ATTACHMENT 4 TO AEP:NRC:1067
PROPOSED REVISED TECHNICAL SPECIFICATION PAGES

(8810190407 881014
PDR ADOCK 05000315
P PDC)

Figure 2. 1-1 Reactor Core Safety Limits
Four Loops In Operation

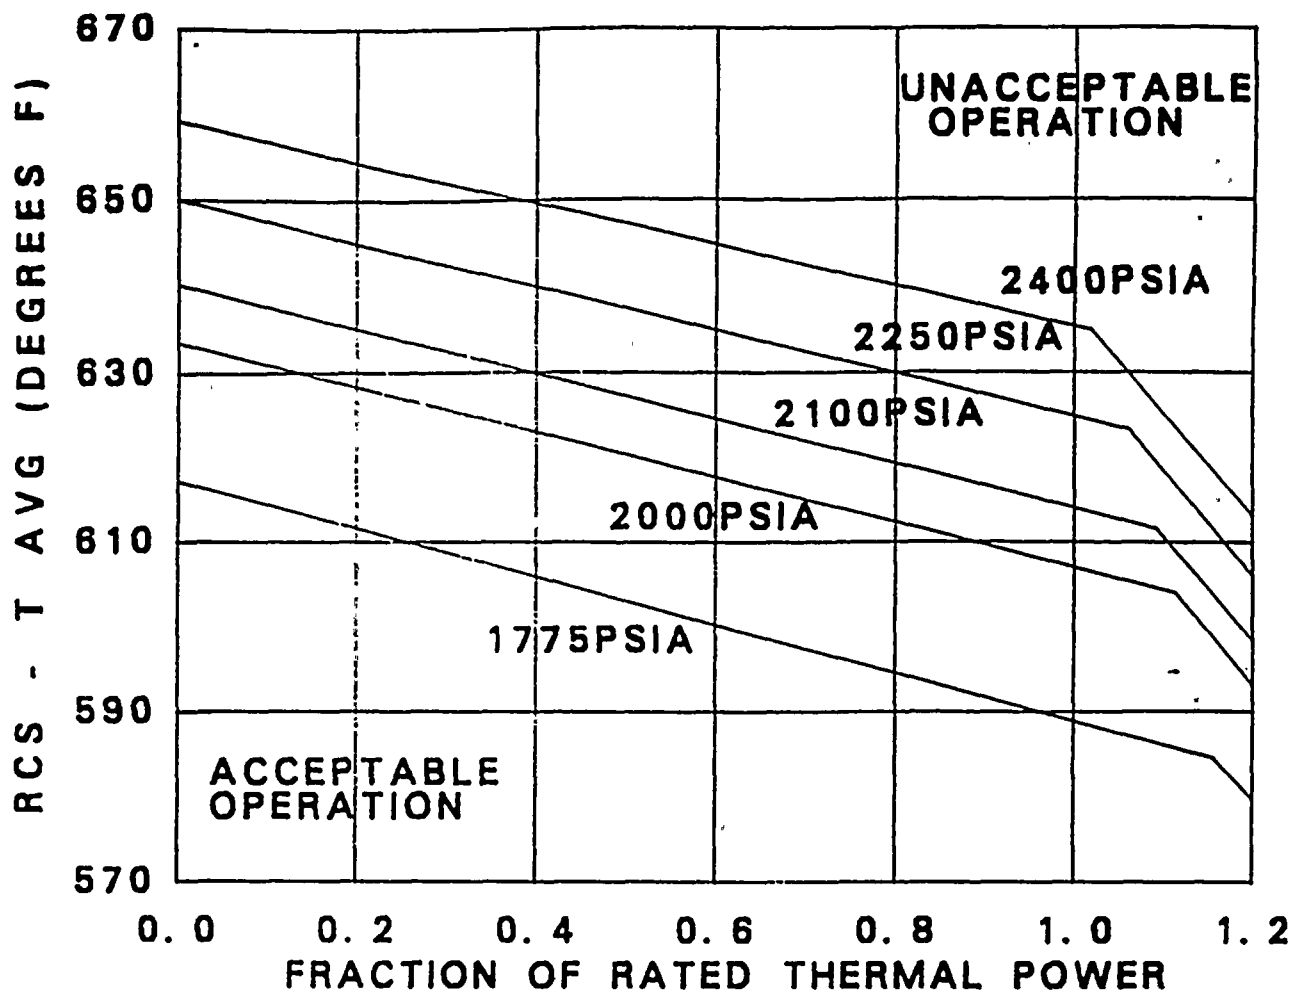
PRESSURE (PSIA)	BREAKPOINTS
	(FRACTION RATED THERMAL POWER, T AVG IN DEGREES F)
1775	(0. 0, 617. 1), (1. 16, 584. 5), (1. 20, 579. 7)
2000	(0. 0, 633. 5), (1. 11, 603. 9), (1. 20, 593. 1)
2100	(0. 0, 640. 3), (1. 09, 611. 5), (1. 20, 598. 3)
2250	(0. 0, 650. 0), (1. 06, 623. 2), (1. 20, 606. 0)
2400	(0. 0, 659. 0), (1. 02, 634. 8), (1. 20, 613. 0)

The curves of Figure 2.1-1 show the loci of points of THERMAL POWER, Reactor Coolant System pressure and average temperature for which the minimum DNBR is no less than the applicable design DNBR limit, or the average enthalpy at the vessel exit is equal to the enthalpy of saturated liquid.

FIGURE 3. 2-3 $K(Z)$ - Normalized $F \text{ sub } Q(z)$
as a function of Core Height

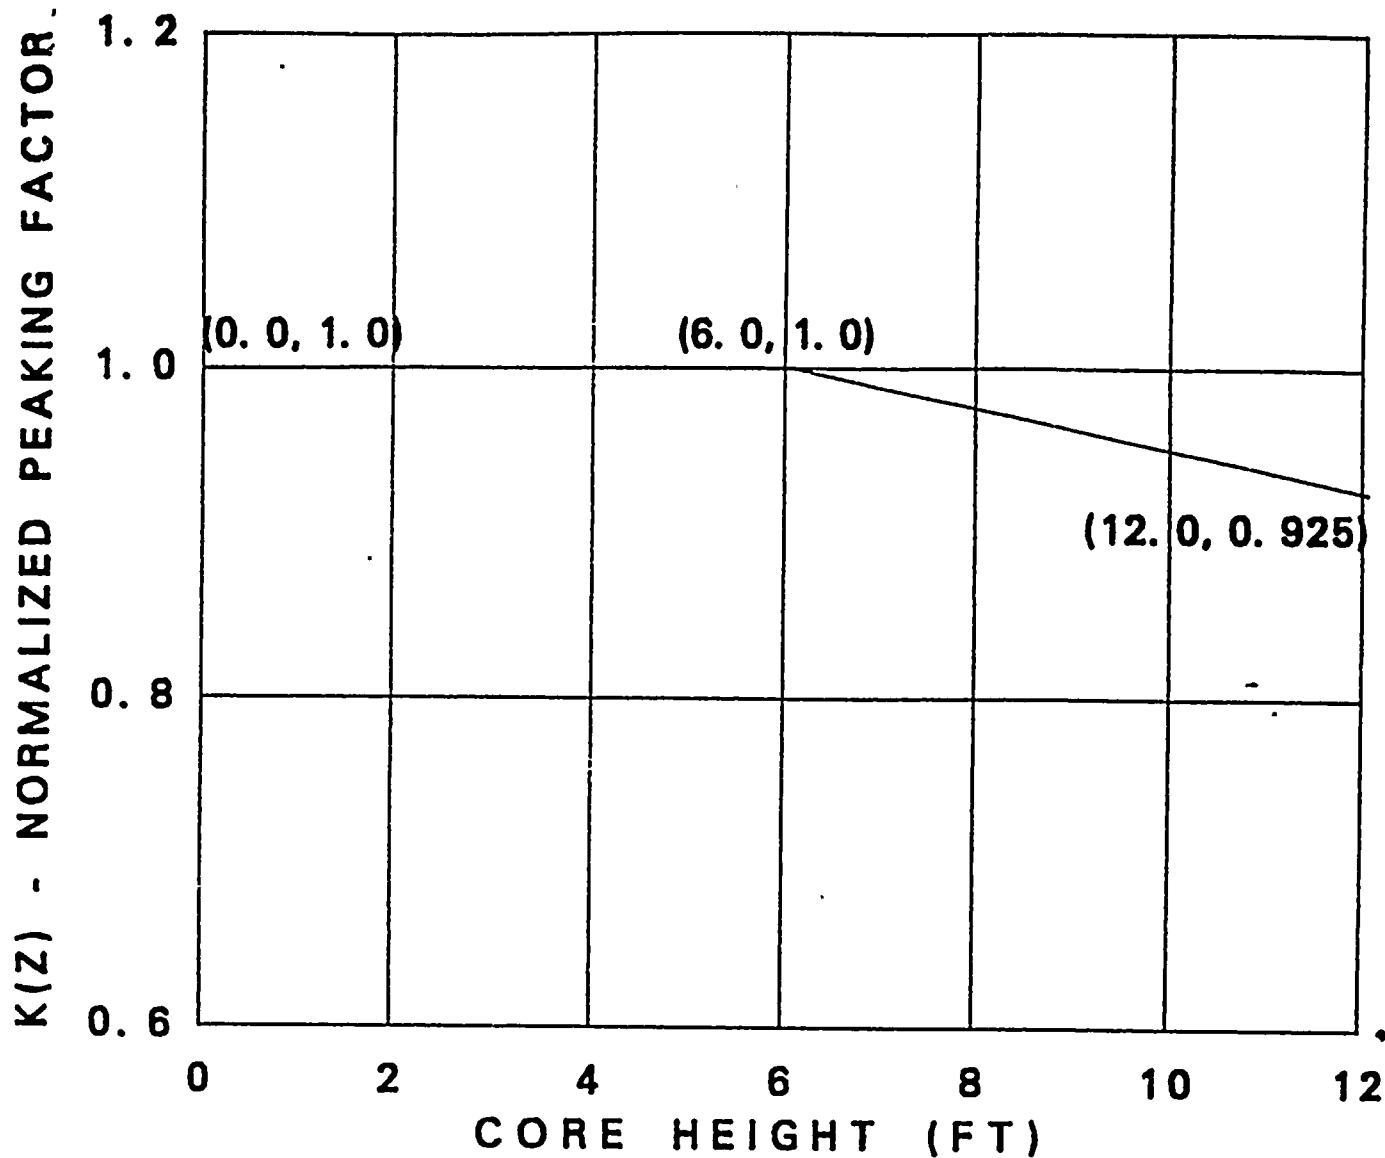
3.2.2 $F_Q(Z)$ shall be limited by the following relationships:

$$F_Q(Z) \leq \frac{[2.15][K(Z)]}{P} \quad P > 0.5$$

$$F_Q(Z) \leq [4.30][K(Z)] \quad P \leq 0.5$$

$K(Z)$ is the function obtained from Figure 3.2-3.
